Water Quality and Quantity Impacts from Proposed South Texas Plant Expansion

Submitted to:
SEED Coalition
1303 San Antonio Street; Suite 100
Austin, Texas 78701

by:
Lauren Ross, Ph. D., P. E.
Glenrose Engineering, Inc.
P. O. Box 1948
Austin, Texas 78767-1948
Telephone: 512/326-8880
Facsimile: 512/326-8881
www.glenrose.com

April 2009

Figure 1. Tritium Concentrations in Relief Well #238

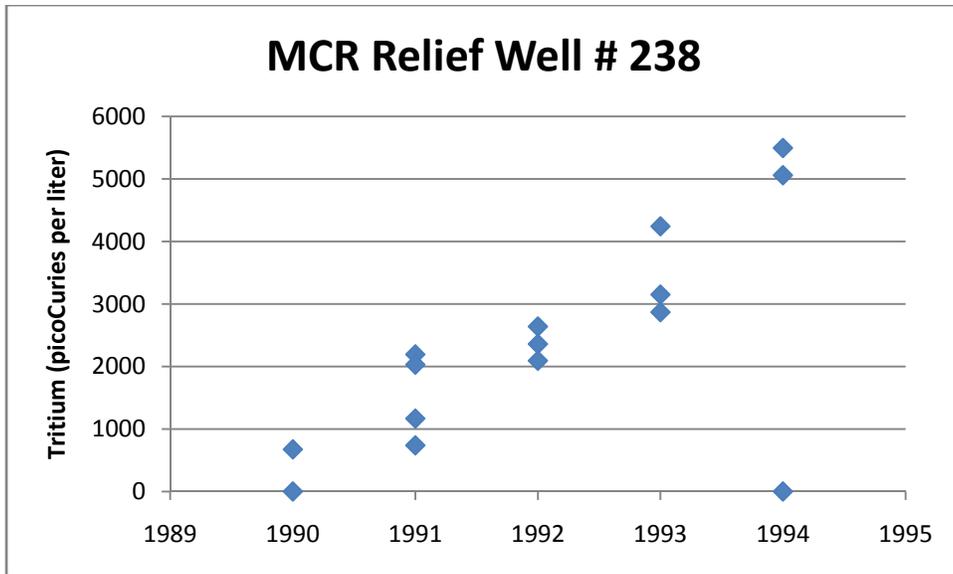
Tritium has been detected in two of the pressure relief wells that collect water leaking from the unlined bottom of the MCR.⁵ Concentrations of tritium have increased in both wells over the original monitoring levels. Tritium concentration changes are illustrated in Figures 1 and 2.

With the addition of two proposed nuclear power generating stations, tritium concentrations in MCR and in the wastewater that is leaking through its unlined bottom are likely to increase. The Environmental Report fails to consider this increase, evaluate its magnitude, or propose any measures to mitigate potential damage to adjacent water and its users.

Figure 3. Current Drought Conditions in Texas

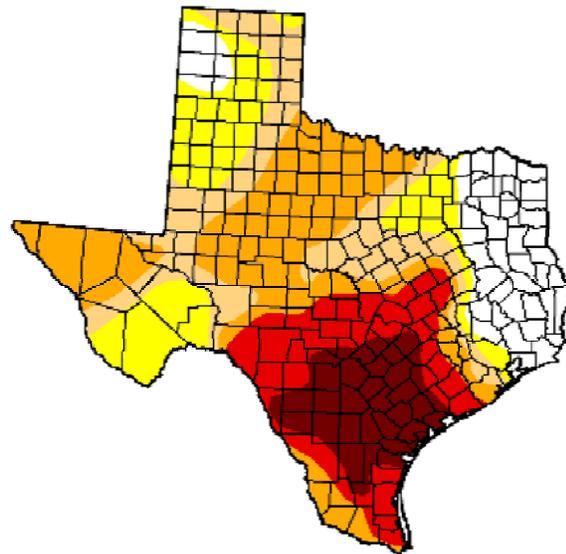
Water from the Colorado River can only be withdrawn when river flow is sufficient to flush saline water from the estuary tidal zone past the plant intake structure. Under low flow conditions the saline quality of the river water is unacceptable for power plant use. South Texas Project has a backup water right for drought conditions of 40,000 acre-feet per year for all four nuclear generating plants. The Environmental Report fails to discuss, however, whether the backup volume can be delivered reliably to this downstream location on the Colorado River at a sufficient flow to be useable during drought conditions. Current drought conditions, illustrated in Figure 3,¹⁵ are classified as exceptional by the U. S. Drought Mitigation Center.

The Environmental Report fails to discuss the environmental affects during conditions when water withdrawal for the nuclear power plants is a significant fraction of the total river flow. From January 1, 2001 through September 30, 2006 there were 69 days when withdrawal was equal to or greater than one quarter of the entire river flow. River flow rates and withdrawal rates for these days is presented in Table 3. On September 16, 2001, the withdrawal was 509 cubic feet per second while the average river flow on that day was 1070 cfs. The STP plant took 48% of the total river flow. The occurrence of days when the percentage of flow withdrawn is a significant fraction of the total river flow would occur more frequently with a doubling of the surface water demand to cool two additional nuclear power generating stations.

This increase in withdrawal and its implications for the environmental health of the Colorado River estuary are not evaluated in the Environmental Report.
